The authors would like to thank all three reviewers for their time, and valuable comments. Their inputs further improved the quality of the paper, especially with the additional comments from Reviewer #3. The comments of each reviewer are addressed separately. The explanation for each question/comment is marked in blue while the actual changes in the manuscript are marked in red with the updated line numbers.

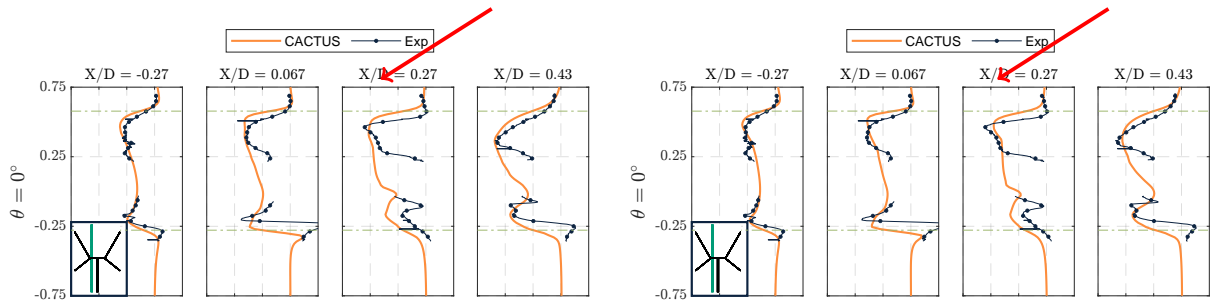
1. Polar data: In the absence of reliable experimental measurements, the presented sensitivity analysis represents a significant improvement in addressing uncertainties in the input polar data. Could you please confirm whether the results shown in the manuscript have been updated to reflect this revised input?

Thank you for the complement. We can indeed confirm that all the results have been updated to reflect this revised input. The differences between the updated results were extremely minor, as mentioned in the last Author Comments. This was due to the blade forces being roughly similar to the first version of the manuscript. We can demonstrate it below by showing a couple of velocity slices below from the first draft of the manuscript and the current version with the polars at an N_{crit} of 4 and a Reynolds number 80K. Below, you can find the minor differences pointed out in streamwise velocity slices along the height for $Y/D = -0.125$ for $\beta = 0^\circ$ which can be most easily seen with the CACTUS results where the red arrow is pointing to at $X/D = 0.27$. The CACTUS results with the updated polars predict marginally higher velocities in the flowfield than before.

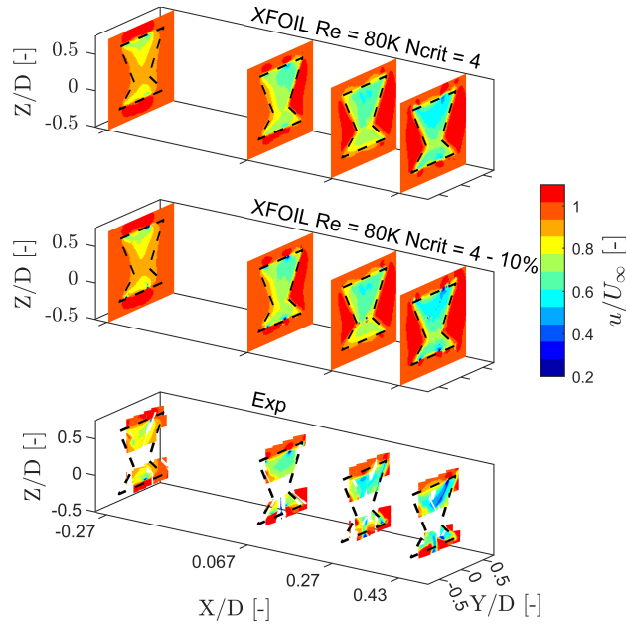
2. Core radius setup: While the sensitivity analysis on the load predictions provides valuable insight, it does not fully justify the chosen value of the core radius—particularly given the study's focus on wake dynamics.

To strengthen this aspect, please also report the influence of the core radius on the mean wind speed and turbulence intensity in the near-wake velocity field.

This is a very fair request. We have shown the influence on the core radius on the mean wind speed. With the free-wake vortex model, we are not resolving the turbulence in the flow - as there are no closure models used for it. Therefore, we have only provide the streamwise velocity contours in the appendix section. As you can see, there is very little difference in the flowfield between the chosen vortex core size as well as the 10% core size. Therefore, as there is no appreciable difference in the streamwise velocity profiles, we believe our choice of vortex core size does not affect the wake characteristics observed in the study.

Comparing the velocity fields with 10% vortex core size and the default at $\theta = 0^\circ$ (Figure 2) shows minor impact in the flowfield that we consider the solver to be relatively independent of the vortex core size.

Figure 3: Virtual camber as a function of chord to radius ratio c/R reproduced from van der Horst et al. (2016).

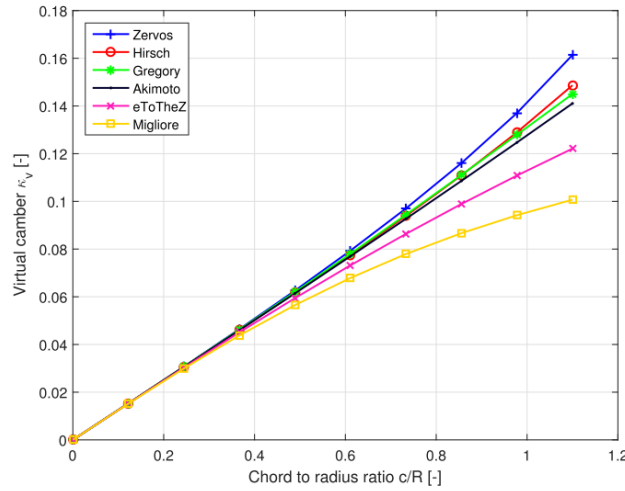
1. Choosing not to include the flow-curvature (virtual camber) effect to "avoid complicating error attribution" is questionable—excluding a known aerodynamic influence makes it harder, not easier, to understand discrepancies. A practical alternative would be to preprocess the airfoil polars by incorporating the effective camber caused by flow curvature under typical VAWT conditions. These adjusted polars could be used as CACTUS input, offering insight into the impact of virtual camber without modifying the code itself.

Firstly, thank you for your critical feedback on the manuscript. We agree that not using the flowcurvature is a limitation in our work. We considered the possibility of preprocessing the airfoil polars using two methods: (1) using the equation from Goude (2012) where the polars are a function of the relative velocity V_{rel} , and (2) using the geometrical virtual camber algorithms or conformal mapping algorithms.

For method (1), if we preprocess the polars with a prescribed V_{rel} distribution, we would encounter further errors as the wake is simulated by the free-wake vortex model. We pointed this out in our previous response to the referee comments, and in the Methodology section.

As for method (2), it is indeed possible to do this. But, as pointed out by van der Horst et al. (2016) (Figure 3), for high chord-to-radius ratios ($c/R > 0.2$), the existing virtual camber and conformal transformation models provide very different results. As most of the X-Rotor blades operate mostly at very high c/R values, we believe it would induce more errors that have not been investigated before, and therefore leads to further uncertainty on the choice of models. Furthermore, as the angles of attack would be very high near the root sections, the errors would likely compound with the uncertainty of the polars at these high angles of attack. That is why we highlighted that these flow curvature models should be tested for the X-Rotor geometry before using them in high-quality scientific work. Once tested, the blade force profiles can be mapped to high-fidelity CFD results to gain insight into which approaches fit best. However, as agreed by Reviewer #2, this is currently out of the scope of the present study. Therefore, we have elaborated more on our justification of not using the flow curvature model for this study in the manuscript.

While this provides a more accurate depiction of airfoil motion in VAWTs, we opt not to include it here for two critical reasons. Primarily, implementing the flow-curvature model (such as Goude (2012)) to a rotor geometry with a large spanwise relative velocity distribution would make it exceedingly difficult to isolate the differences observed between CACTUS and experimental results to other factors. Moreover, geometrical virtual airfoil transformations (such as Hirsch and Mandal (1984)) show large inaccuracies at high chord-

to-radius ratios ($c/R > 0.2$), which is the regime that most of the X-Rotor blade operates in. Secondly, as CACTUS does not come inherently with a flow curvature correction model, implementing it ourself in the source code would be outside the scope of this study. Furthermore, attempting to pre-emptively correct the airfoil polars without calculating the relative velocities would result in unwarranted errors in CACTUS.
